ADDENDUM NO. 2 – Date: March 5, 2021

RE: RSD- Exterior Paint and Misc. Cosmetic Repairs at Janson ES and Savannah ES

FROM: Rosemead School District
3907 Rosemead Blvd.
Rosemead, CA 91770

1 JANSON ES | SITE PLAN - SCOPE OF WORK
SCALE: 1/32" = 1'-0"

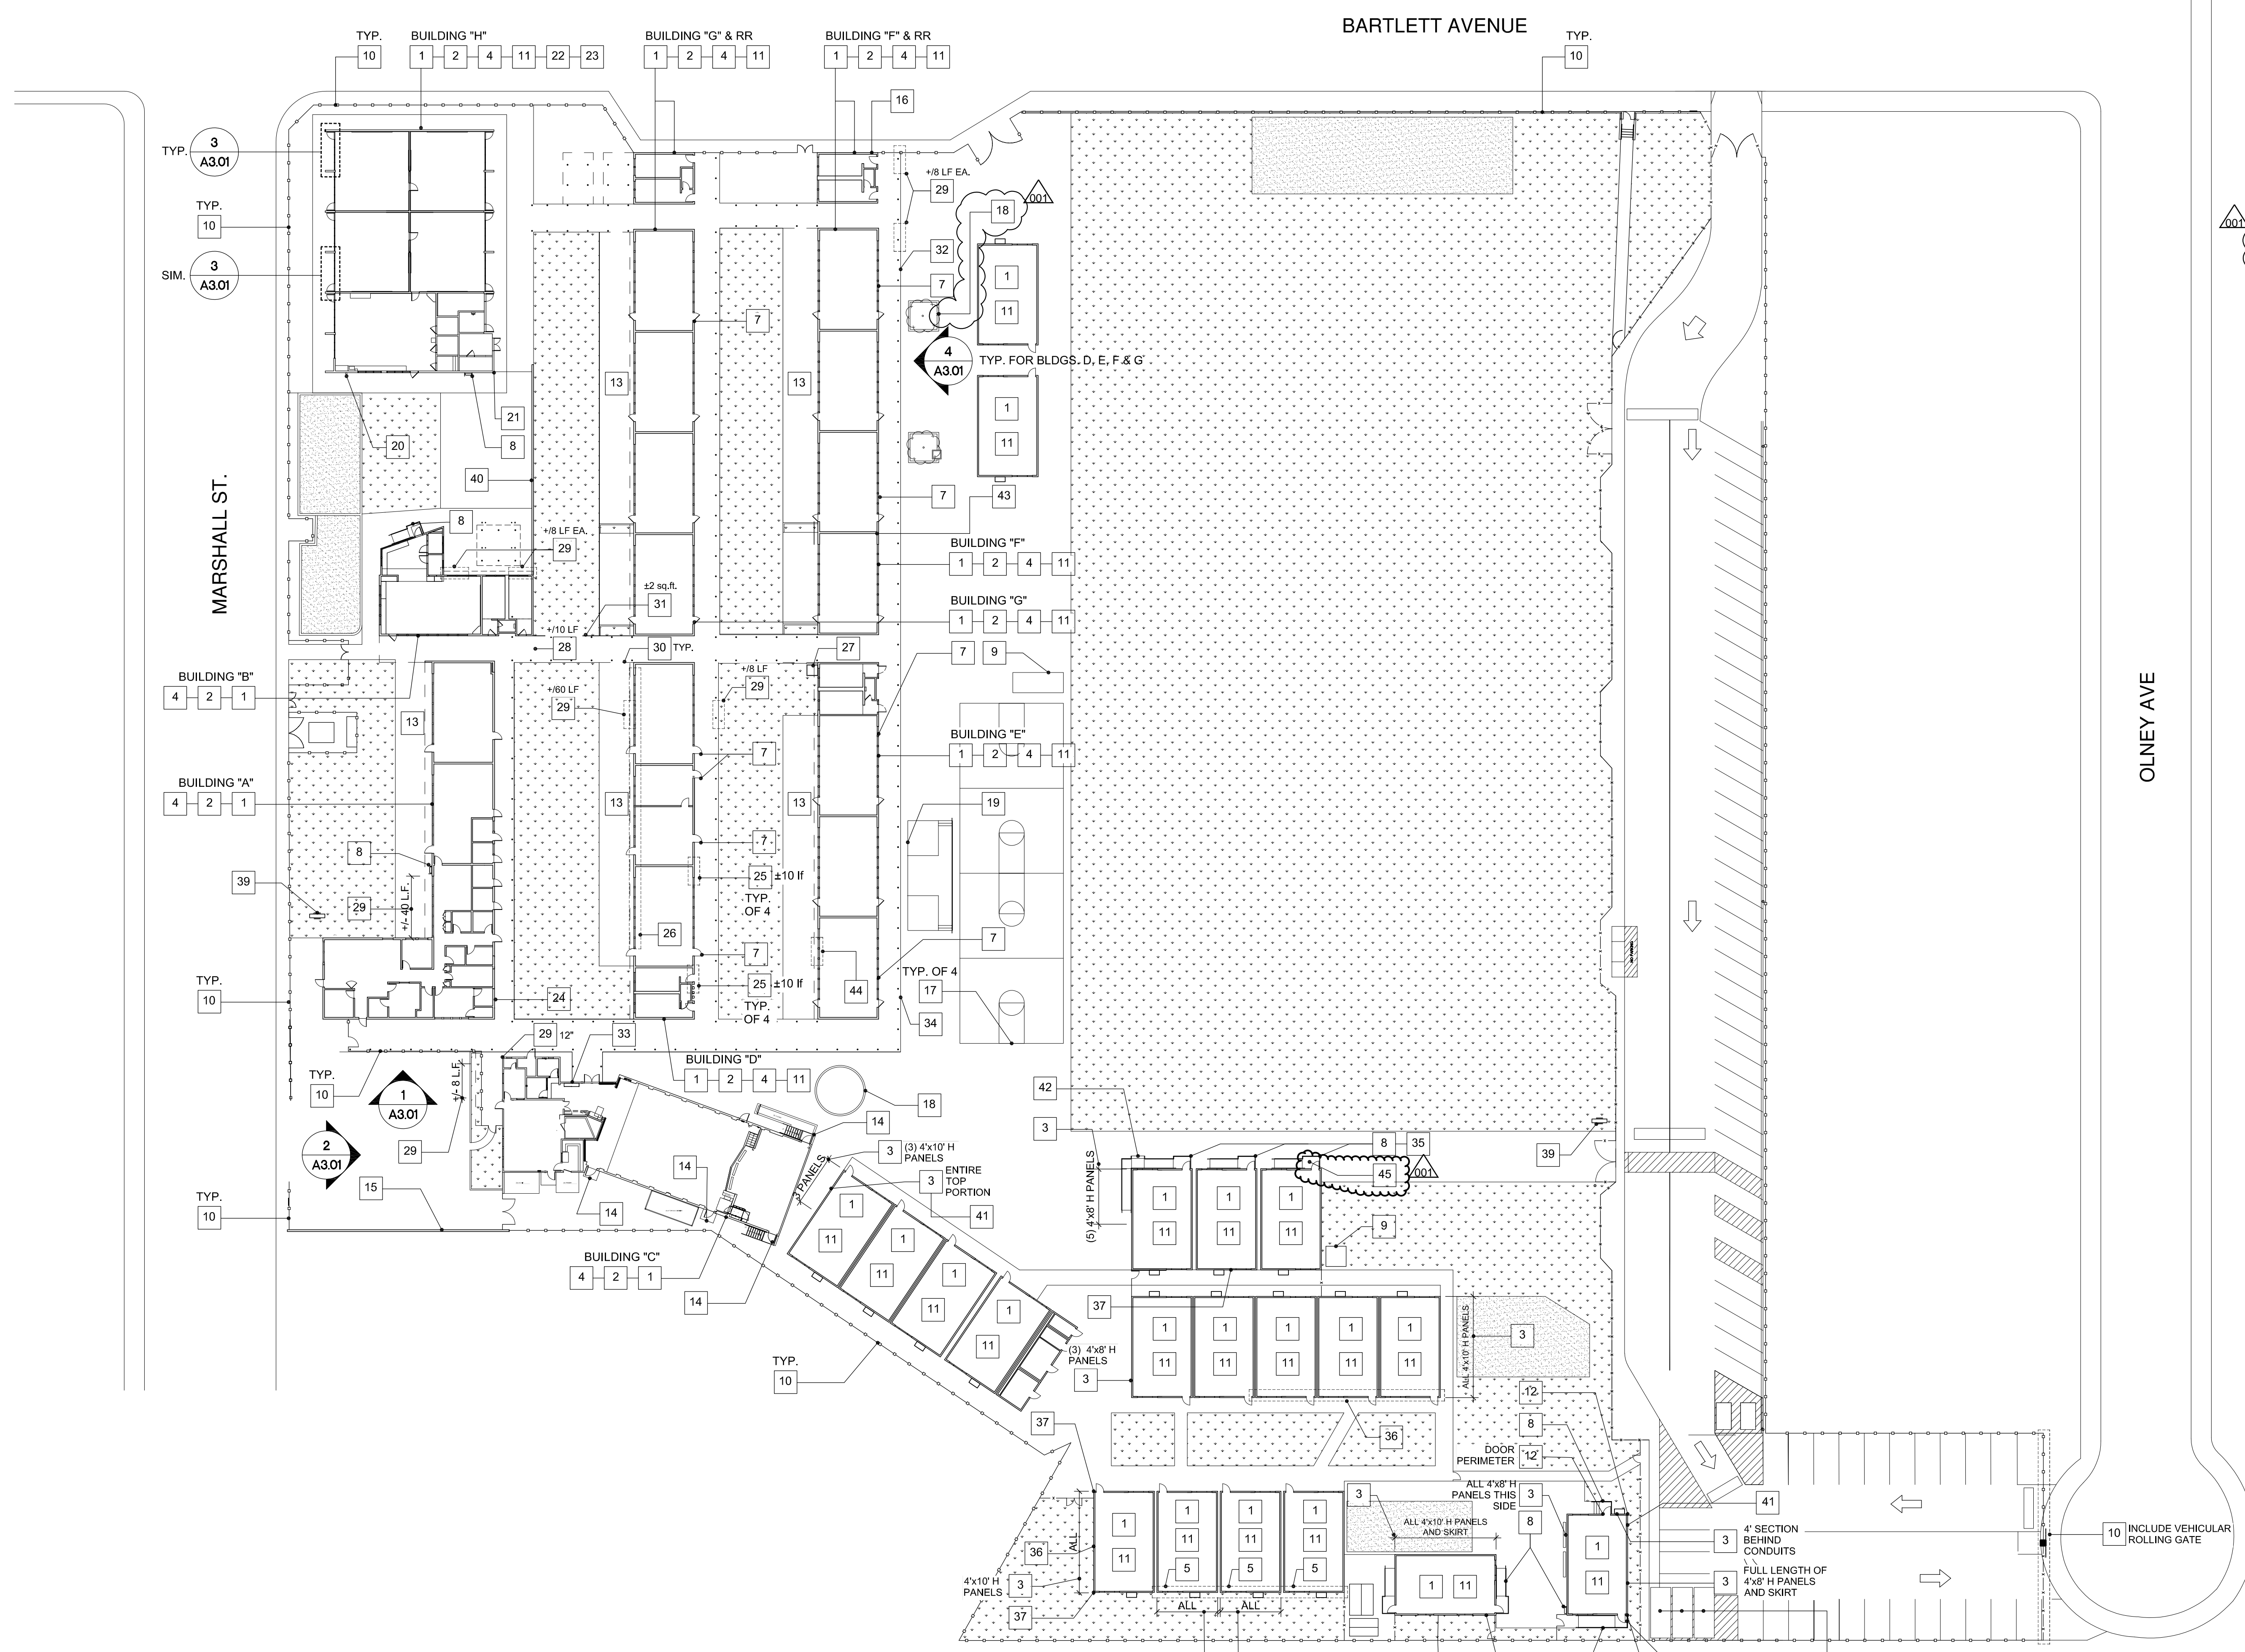
1. Janson ES Site, Sheet A1.01:

- a) **REVISED:** General Site Note “E”
- b) **ADD:** General Site Note “Q”
- c) **REVISED:** Key Note No. 9
- d) **ADD:** Reference to Key Note 18 on North Planter
- e) **ADD:** Key Note No. 45 and reference on the Site Plan

- 1. Question:** What is the scope for the "quotes" located on the eave's fascia boards?

- 4. Question:** Is the tree well on the North Side of Janson's play yard included in the Scope of Work?

- 5. Question:** At Janson ES: Is the repair of the underside of portable plywood overhang included in the Scope of Work?

- 6. Question:** Clarification of (E) storage "barns" (Applicable for both Sites)

- 7. Question:** Are the pipes and conduits on top of (E) canopies included in the Scope of Work? (Applicable for both Sites)

- 1. Question:** keynote 17 – Alternate 1: Are we doing the painting of fence in alternate where only noted on drawings with item 17? The reason on the North East side there is some fence by the parking lot and behind 4 Bungalows. See sketch. Please clarify

Response: Quotes on eave's fascia boards shall be painted over and re-painted to match (E). See revised Site Plan. Comply with General Site Note "Q" on sheet A1.01

Response: Yes, painting of planter is included. See revised Site Plan on sheet A1.01

Response: Yes, comply with Key Note No. 45 on revised Site Plan, sheet A1.01.

Response: Existing storage "barns" are not to be included in the Scope of Work. Comply with revised Key Note No. 9 on sheet A1.01 for Janson ES Site and with revised Key Note No. 16 on A1.01 for the Savannah ES Site

Response: No. Comply with revised General Site Note "E" on sheet A1.01 for Janson ES and Savannah ES set of drawings.

Response: Portion of fencing indicated on the Site Plan provided by Omega Construction is chain link, not wrought iron. Therefore, no paint scope is included in this portion of fencing. However, the only portion of fencing to be painted along the East fence is located at the South turn of the wrought iron fence as shown on sheet A1.01 of the attached revised drawings.

1 SAVANNAH ES | SITE PLAN - SCOPE OF WORK
SCALE: 1/32" = 1'-0"

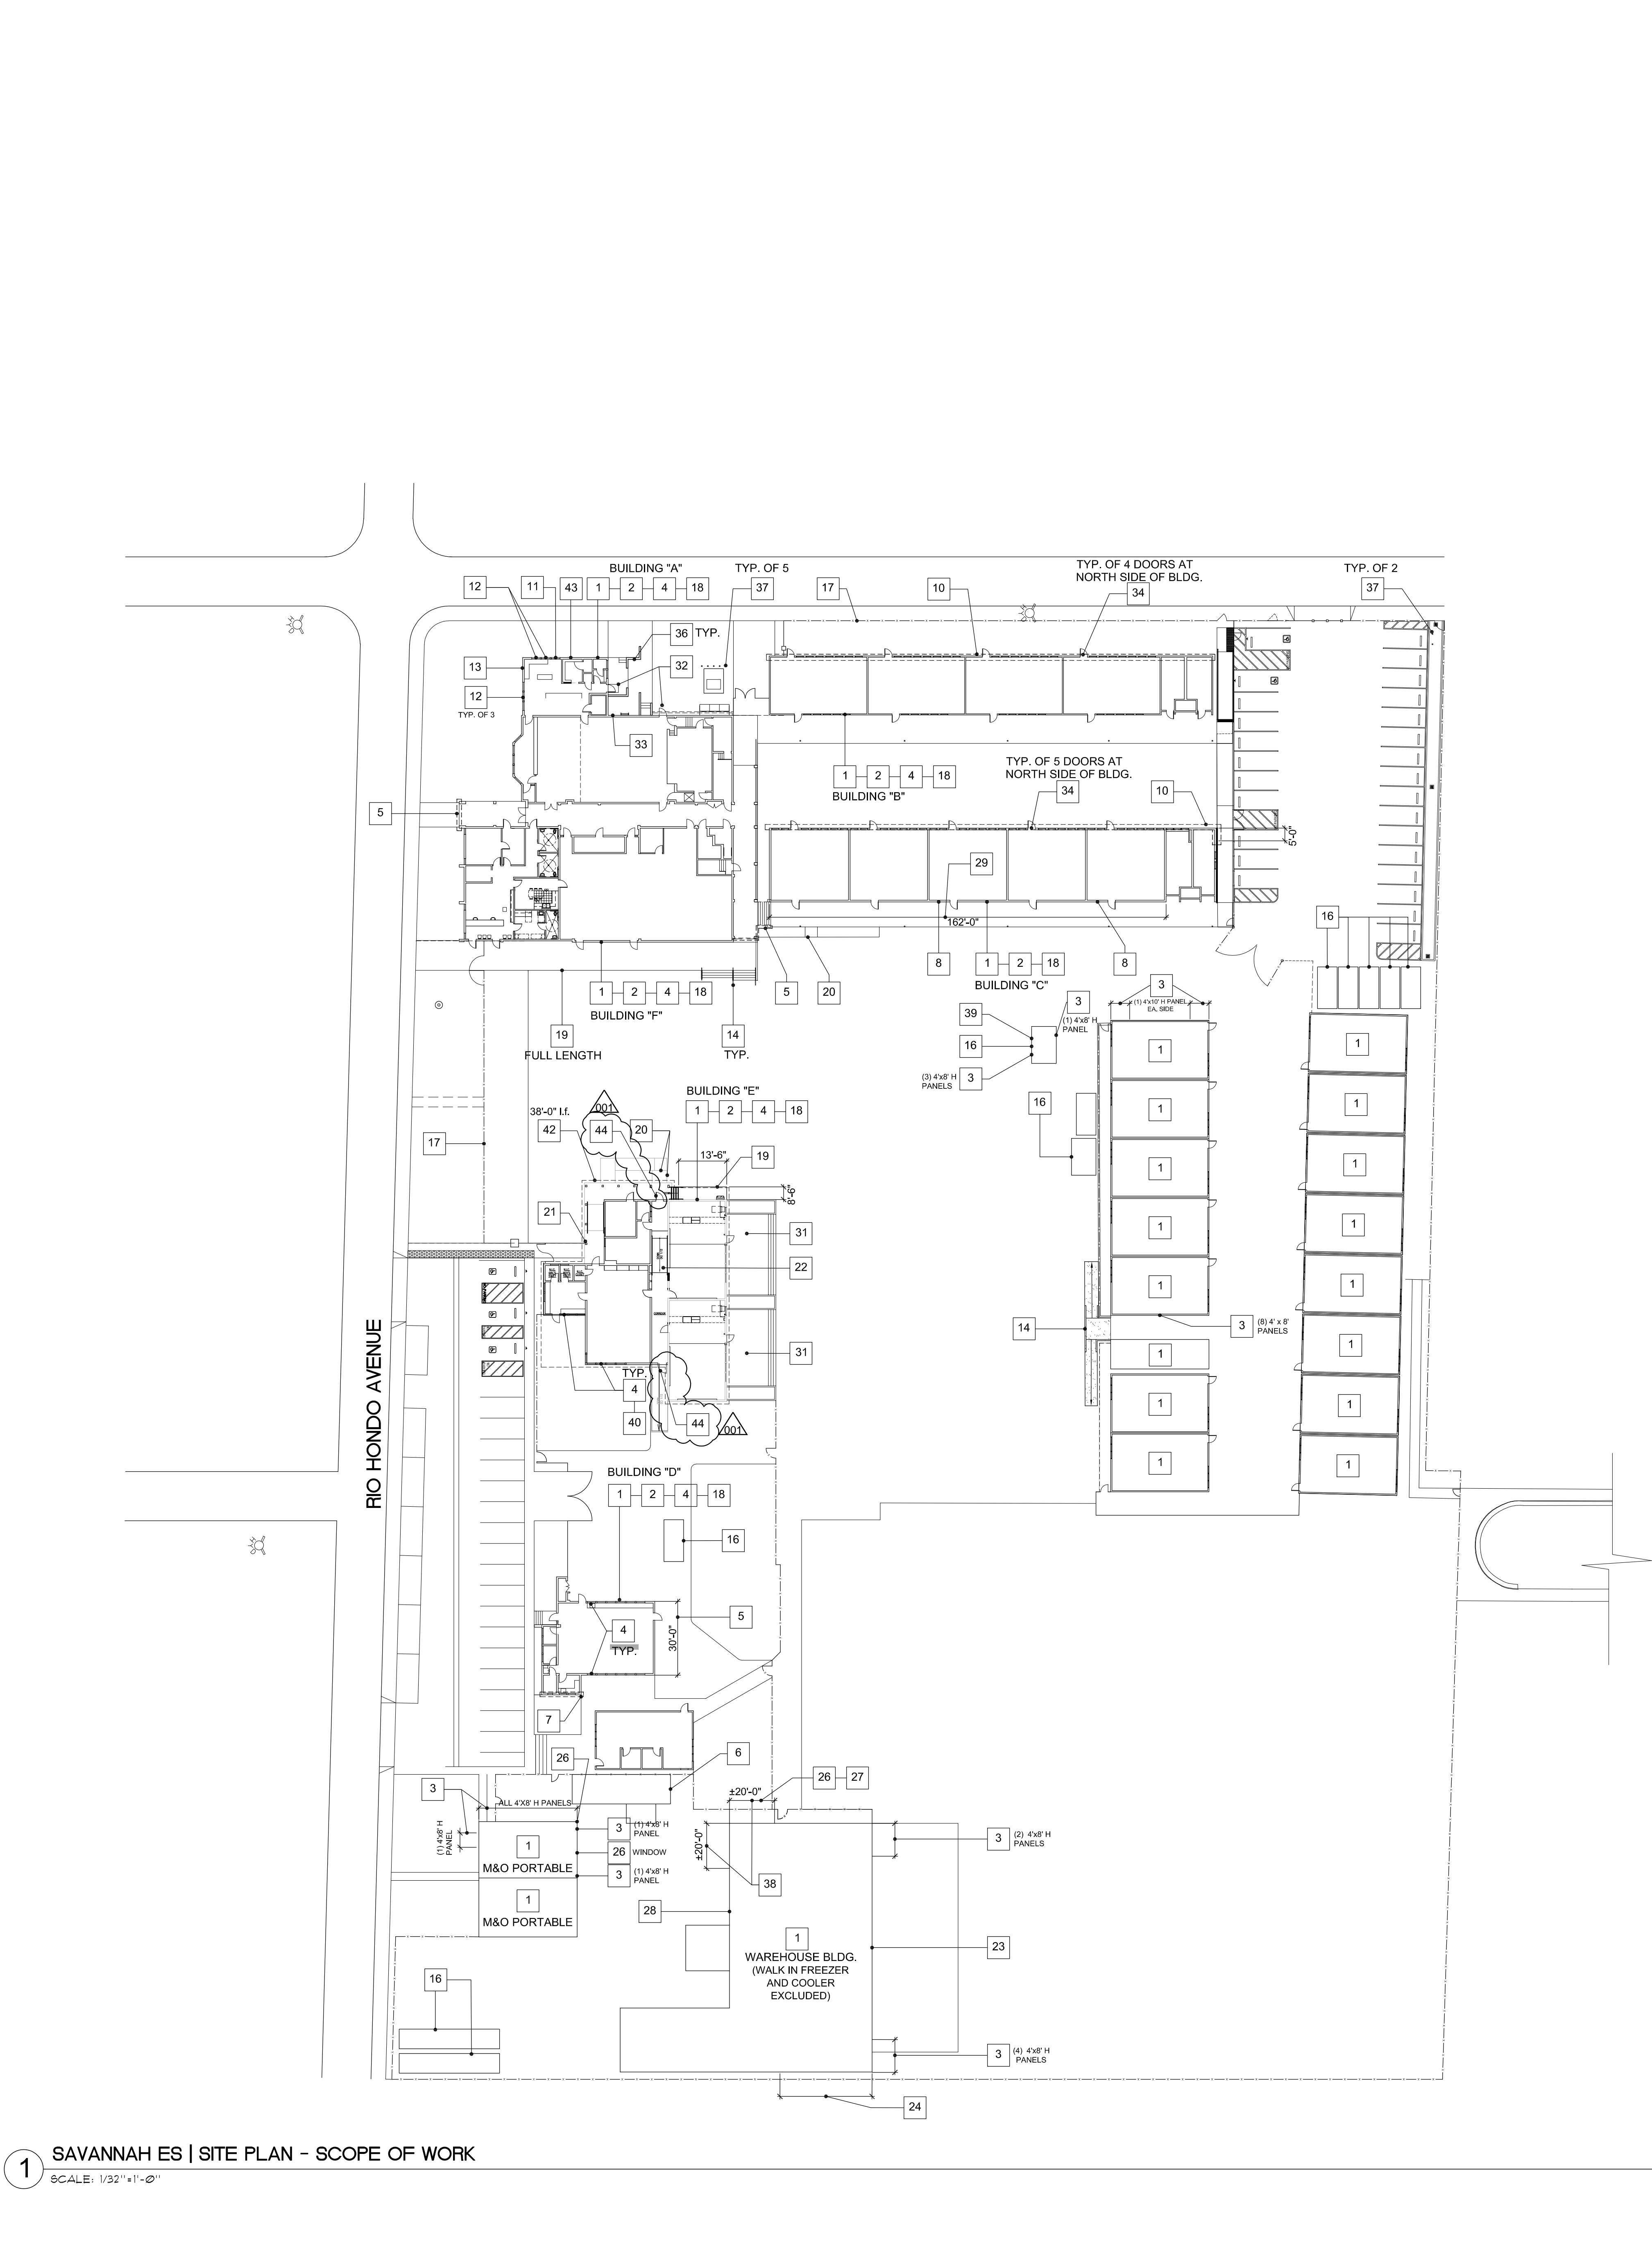
2. Savannah ES Site, Sheet A1.01:

- a) **REVISED:** General Site Note “E”

- b) **ADD:** General Site Note "S"
- c) **REVISED:** Key Note No. 16
- d) **ADD:** Key Note No. 44 and reference on the Site Plan

- 8. Question:** At the Savannah Site: Will (E) CMU that is currently not painted be provided with new paint?

- 9. Question:** At the Savannah Site: Do the doors at the North and South ends of the breezeway going to be painted in full (all sides)?

Response: No, Comply with General Site Note "S" on sheet A1.01 of the Savannah ES Site

Response: Yes, comply with Key Note No. 44 on sheet A1.01 of the Savannah ES Site
